Report Committee of Adjustment

File: A-2024-0041

Address: 4 Alderway Drive

The purpose of the application is to request one (1) variance to permit a total of two (2) parking spaces whereas the by-law requires three (3) parking spaces for a 3 unit dwelling.

1 PROPOSED BSMT PLAN
1:64

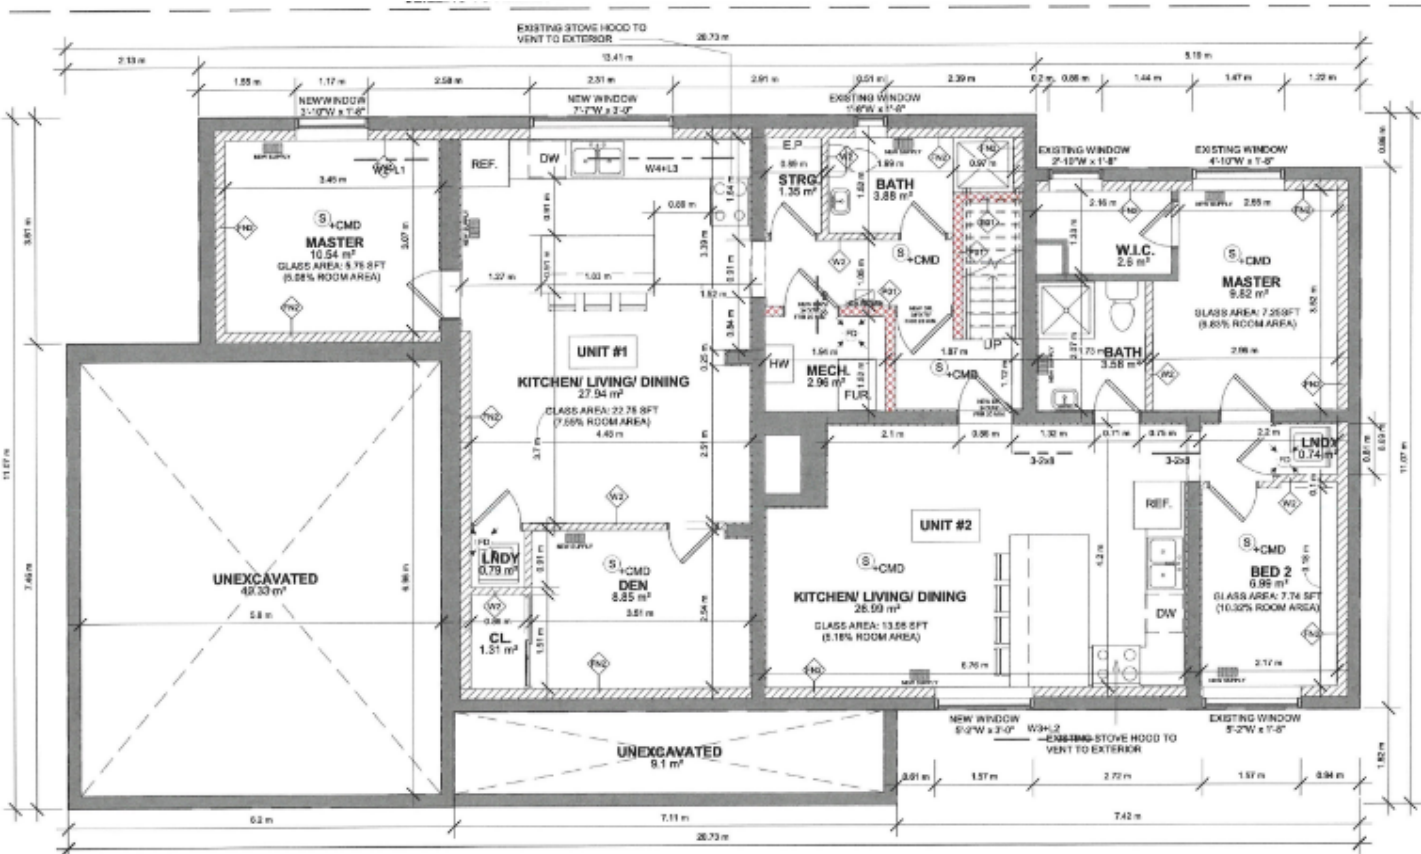
recommendation to the Committee of Adjustment. In reviewing the application the Building Department had raised concerns with the proposed floorplans and the shared means of egress for the shared basement units (refer to Appendix A). Staff noted that the shared means of egress for the proposed basement units, as shown on the proposed floor plans, does not comply with the requirements of the Building Code. An egress window is not an acceptable second means of egress when proposing a shared entrance. Egress must satisfy OBC Div B, 9.9.9 as a structure with 3 dwelling units in no longer a 'house' as defined by the Building Code and part 11 Compliance alternative for a 'house' no longer apply.

These concerns were raised with the applicant on March 06th, 2023 and advised that they will need to be addressed through an amended proposal and updated concept plan. While these OBC concerns are not directly related to the requested variance to reduce the number of required parking on site, a deferral of the application will allow additional time for the applicant to consider alternative layouts to accommodate the creation of a second additional residential unit. Staff will be working closely with the applicant to resolve any concerns prior to presenting a recommendation to the Committee of Adjustment. Therefore, staff are recommending that this minor variance application be deferred no later than the last hearing of May 2024 to allow sufficient time for the applicant to support the proposed 3 unit development, as well as include a revised plan to address the above noted matters.
